PROJECT NAME	HILO WWTP REHABILITATION & REPLACEMENT PROJECT PHASE 1	
PROJECT NUMBER	WW-4705R	
SUBMITTAL #	001.1	
SPECIFICATION SECTION	01500	
<b>SHOP DRAWING REVIEW</b>		
<b>ENGINEER'S REVIEW</b>		<b>CONTRACTOR'S ACTION</b>
<input checked="" type="checkbox"/> No Exceptions		Confirm
Make Corrections Noted		Resubmit
Rejected		
Comments Attached		
<p>Engineer's review is for general conformance with the design concept and the contract requirements. Markings or comments shall not be construed as relieving the Contractor from compliance with the project plans, specifications nor departure therefrom. The Contractor remains responsible for details and accuracy, for conforming and correlating all quantities and dimensions, for selecting fabrication processes, for techniques of assembly, and for performing his work in a safe manner.</p>		
<b>R.M. TOWILL CORPORATION</b>	Date	5/13/25
	By	 Michael S. Hong – Construction Manager

<b>Owner:</b>	County of Hawaii	<b>Date:</b>	5/7/2025
<b>Contractor:</b>	Nan, Inc.	<b>Project No.:</b>	WW-4705R
<b>Project Name:</b>	Hilo WWTP Phase 1	<b>Submittal Number:</b>	01500-001.1
<b>Submittal Title:</b>	Resubmittal -TEMPORARY FACILITIES & CONTROLS FIELD OFFICE

OWNER'S TRAILER PLAN

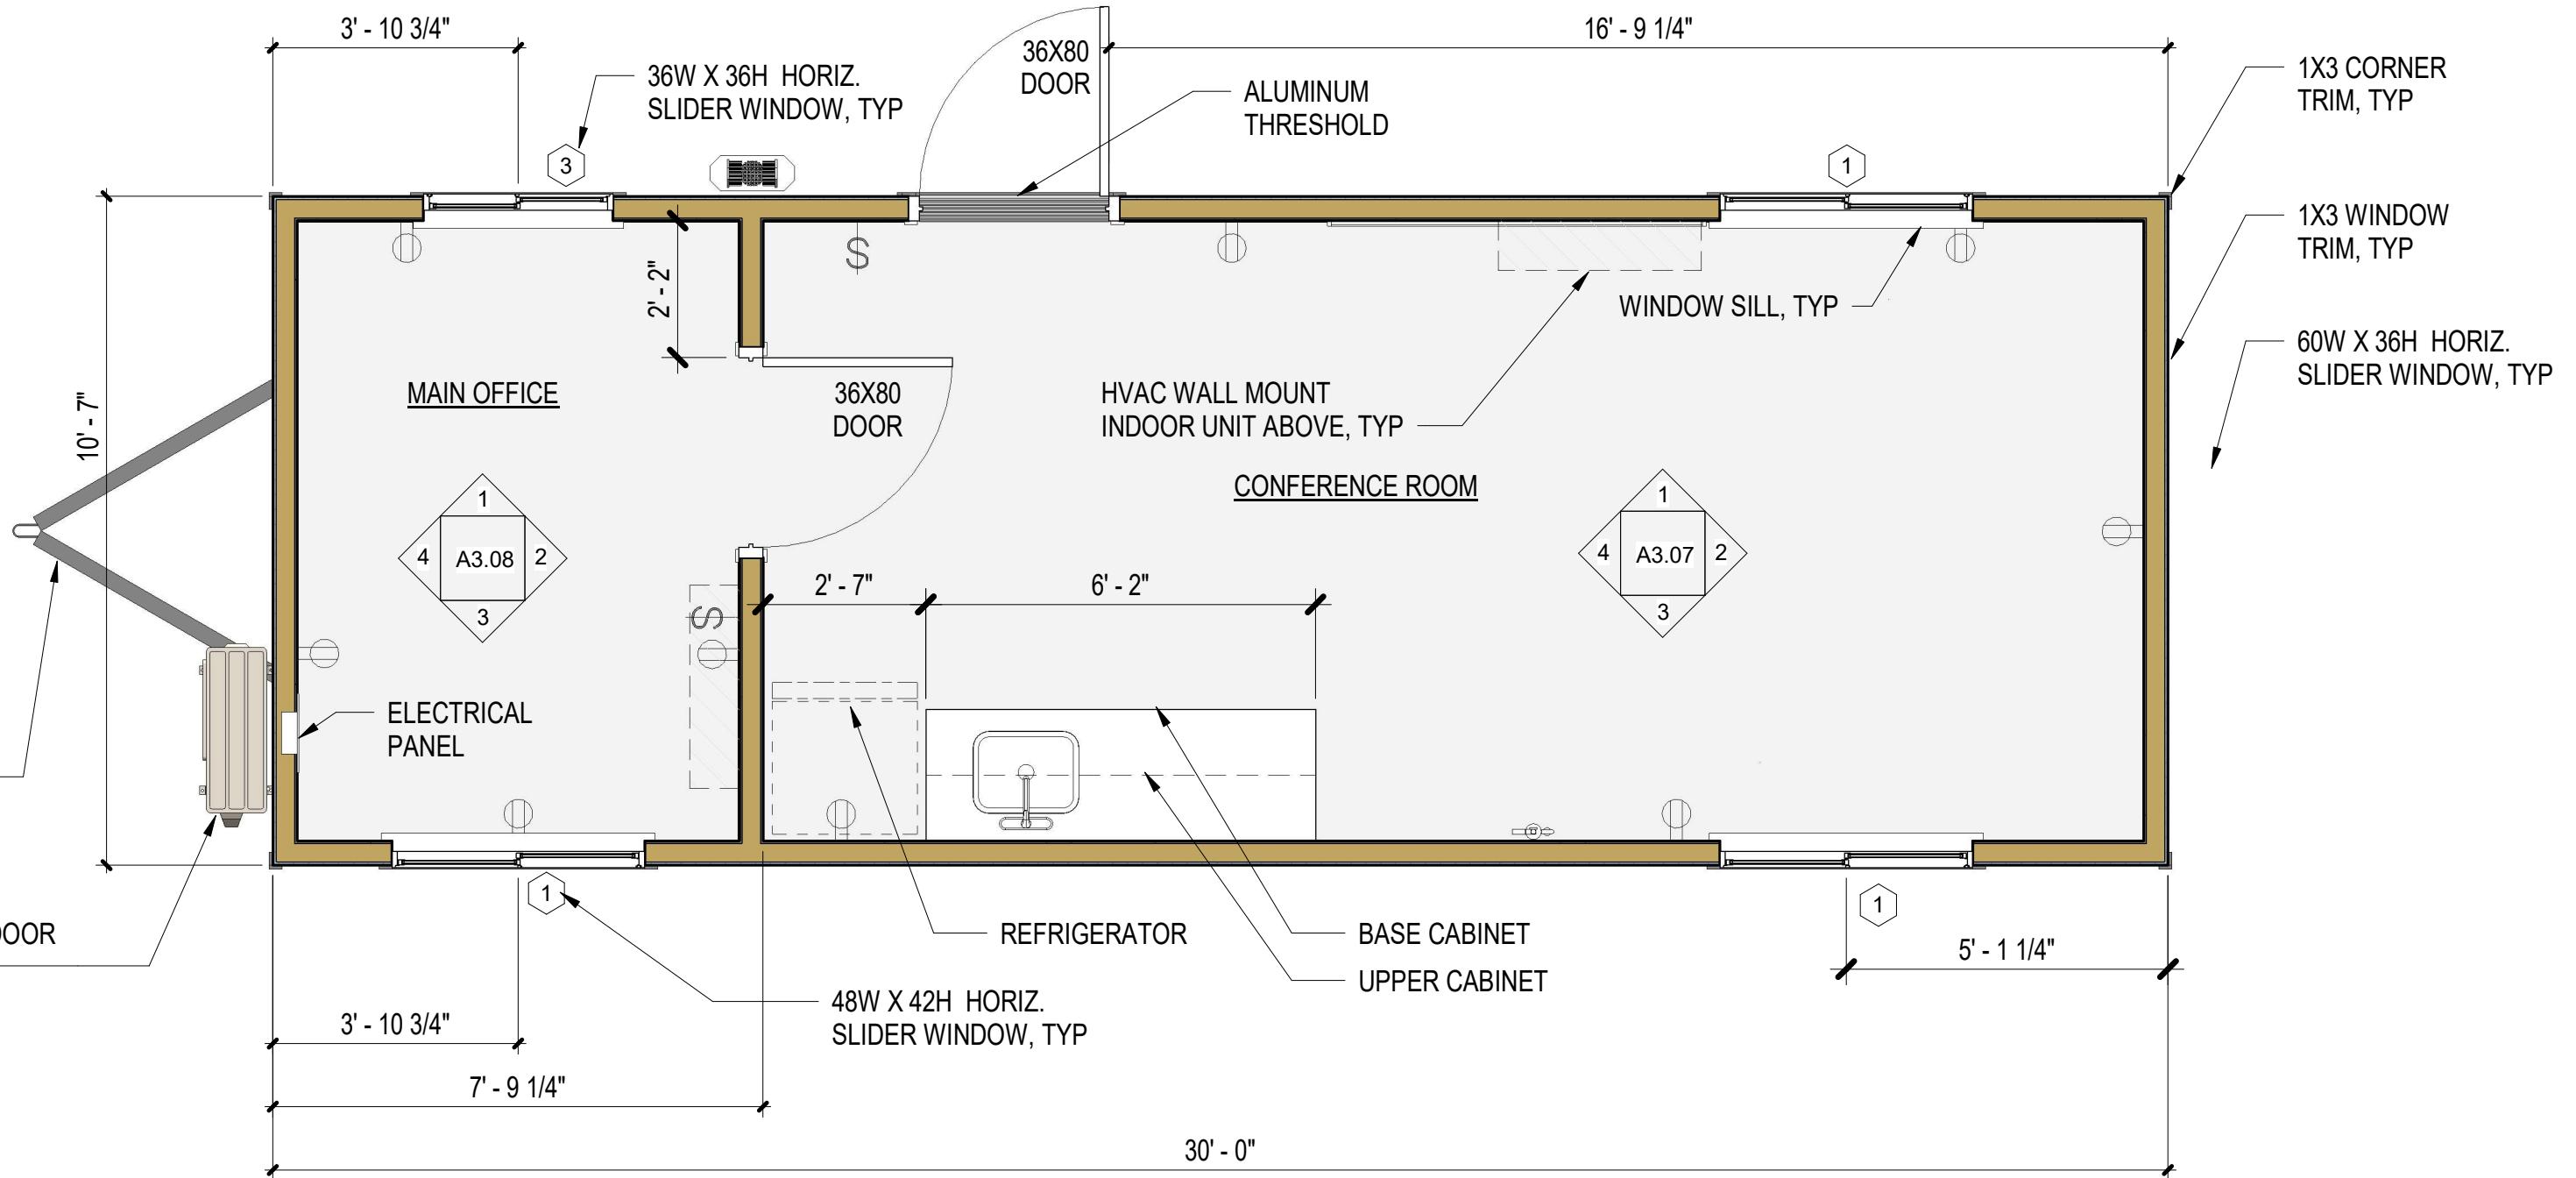
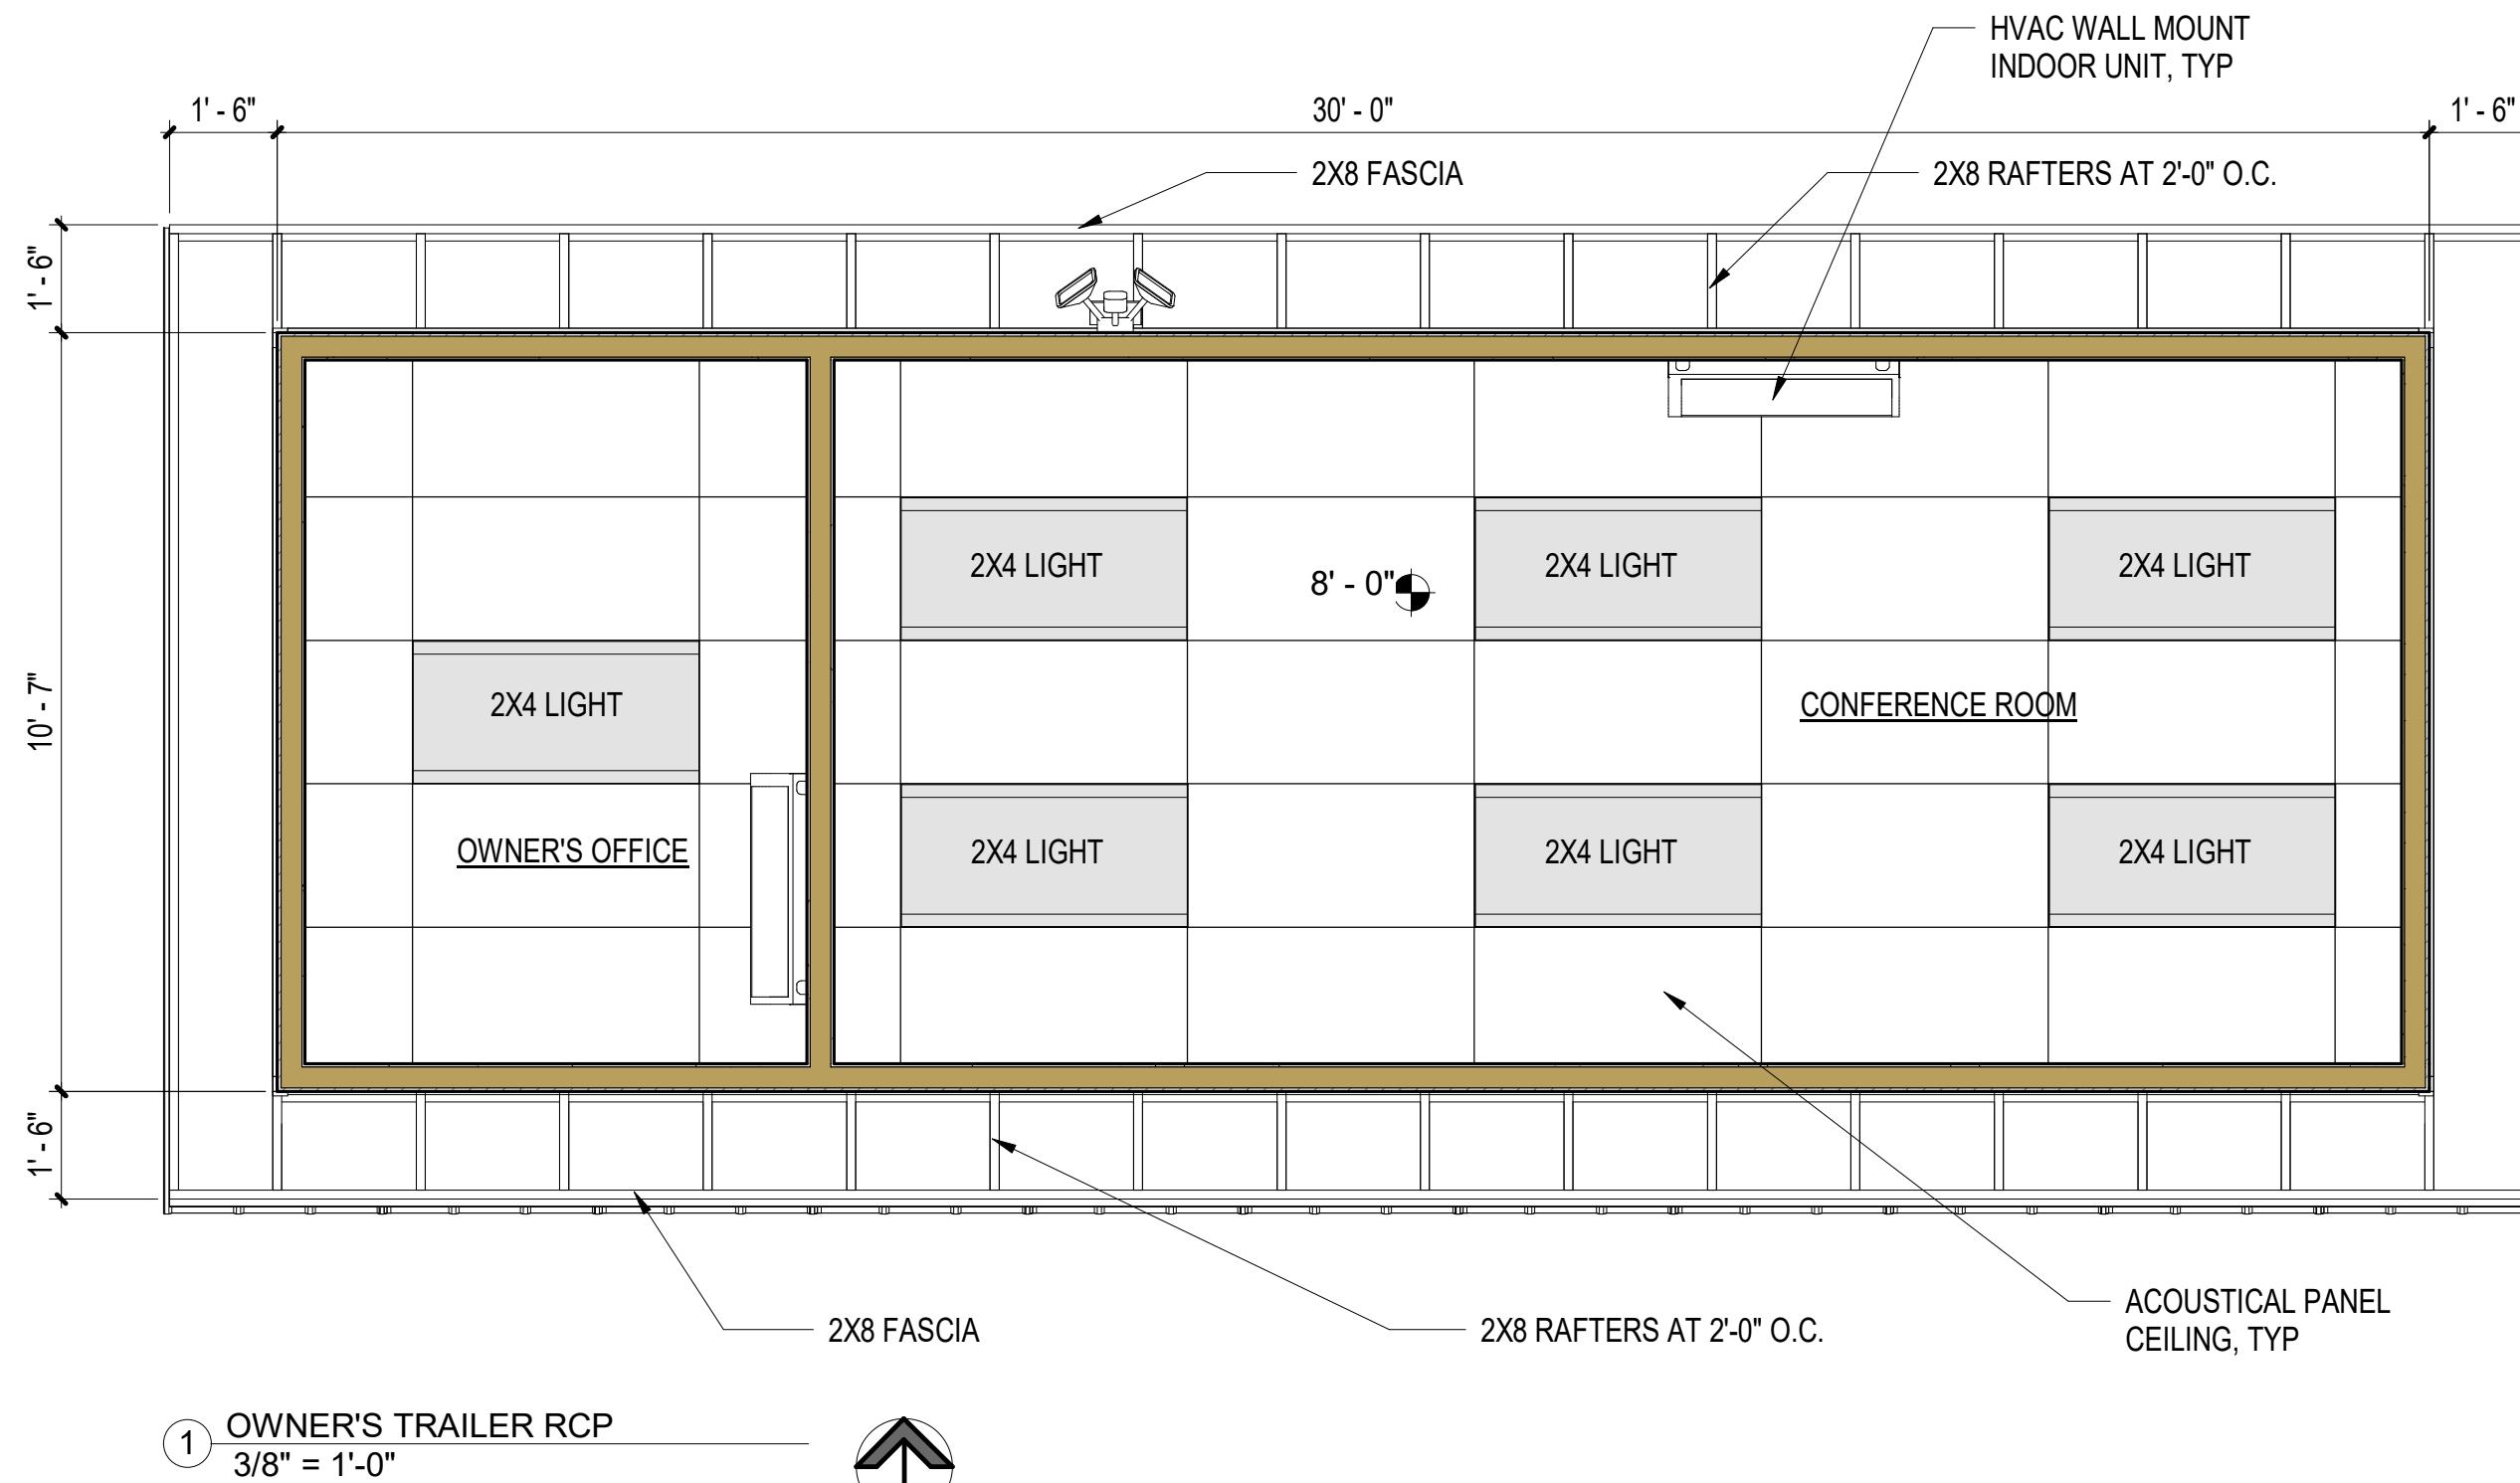
- Specification Section 01550 paragraph 1.12.9
      - "Appropriate number and type of fire extinguishers for each field office."
  - Owners Trailer appears to have two HVAC Wall Mount Indoor Unit inside conference room as shown in sheet A3.01. Please check if this is a mistake.

- Location of kitchen sink not provided in Owners Field Office and Engineer's Field Office 2
    - Incorporated: see dwgs A3.01, A2.01 respectively
  - Specification Section 01550 paragraph 1.12.B lists a number of items required for the field offices. Provide submittal information for the following items:

- Incorporated: See Dwgs A5.03
- Incorporated: See Dwgs A 1.07
- Incorporated: see dwgs A3.01
- Response: This submittal to be reviewed by owner. Does not to be displayed on dwgs. Contractor to provide per specifications

**A5.03**

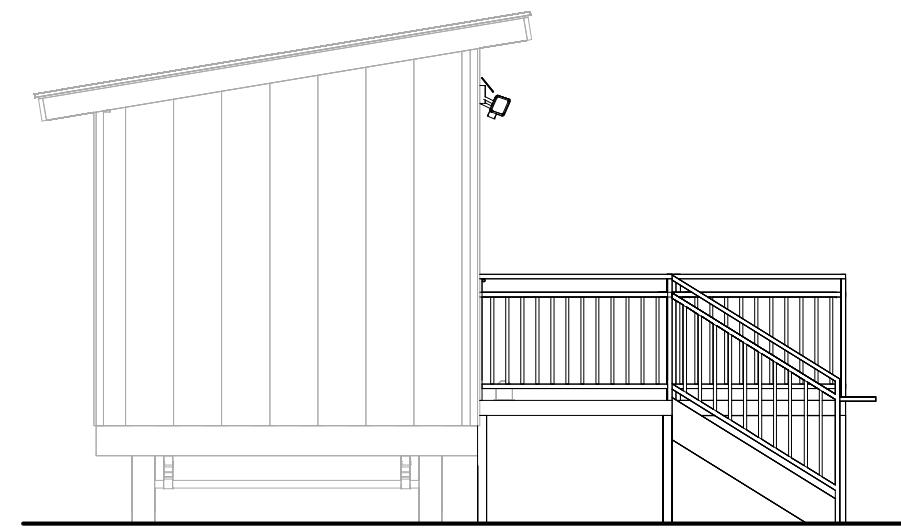
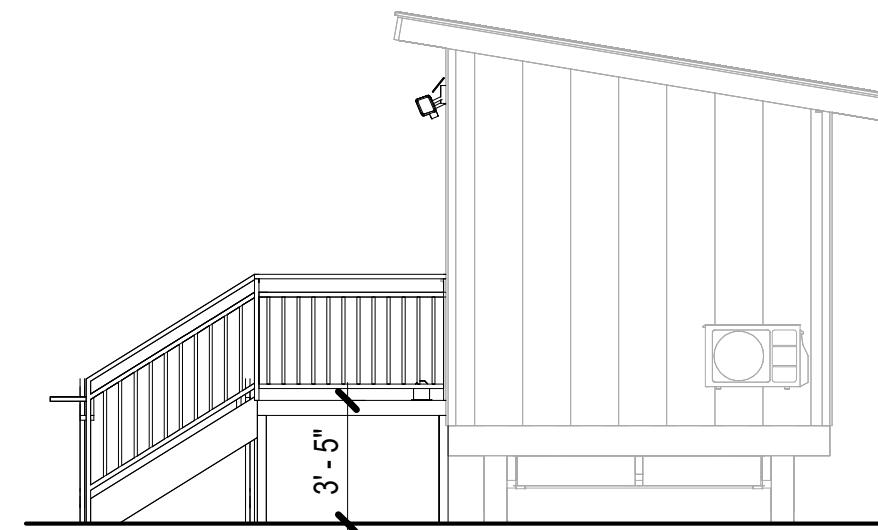
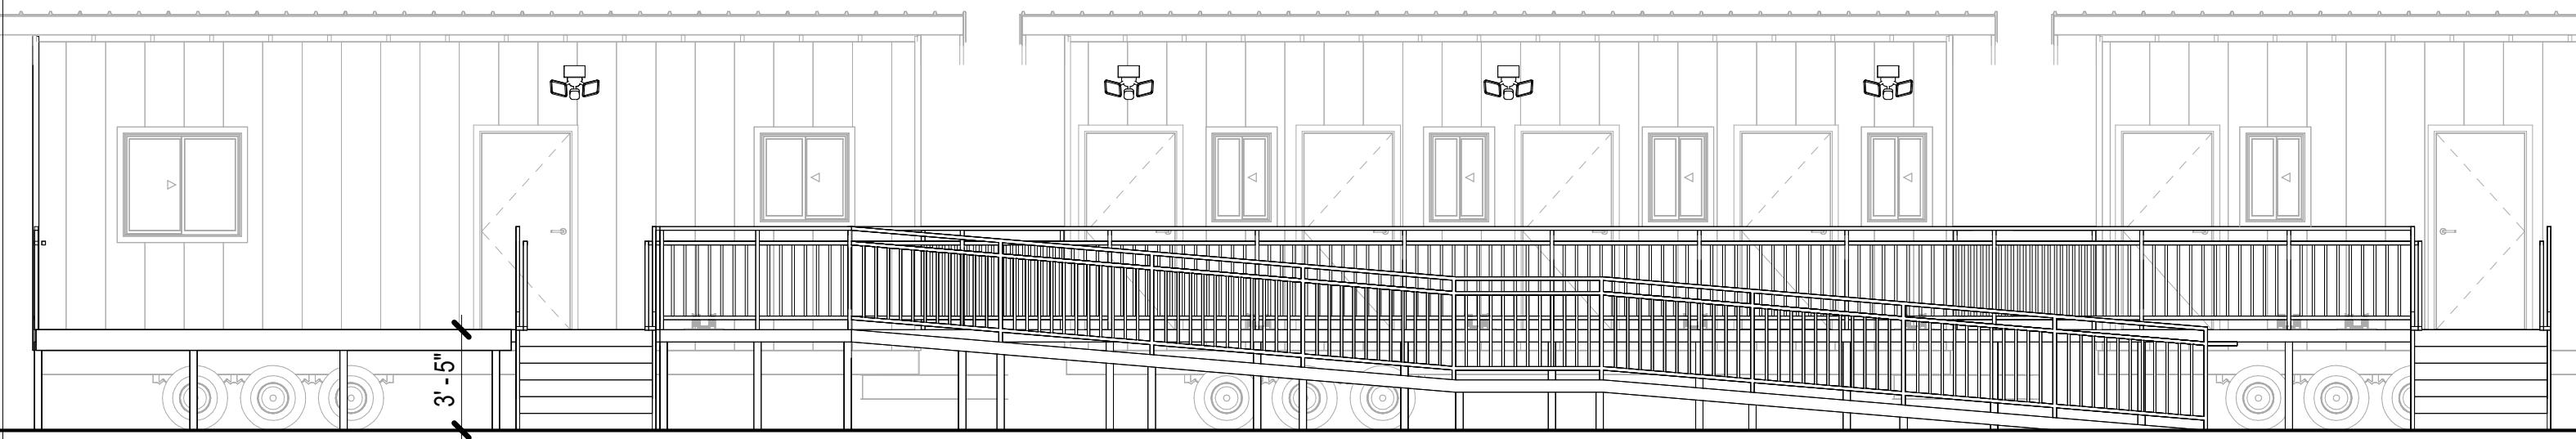
- "Exterior materials: Skirting for underpinning of field offices."
    - Specification Section 01550 paragraph 1.12.5
      - "Provide wood stairs and handrails at each entry."

- a. Porch landing at each entry shall be 5 feet by 5 feet.
        - b. Provide an ADA-compliant handicapped ramp for at least 1 exterior stairway of each office. A single ramp, as long as ADA-compliant, may serve more than 1 field office."
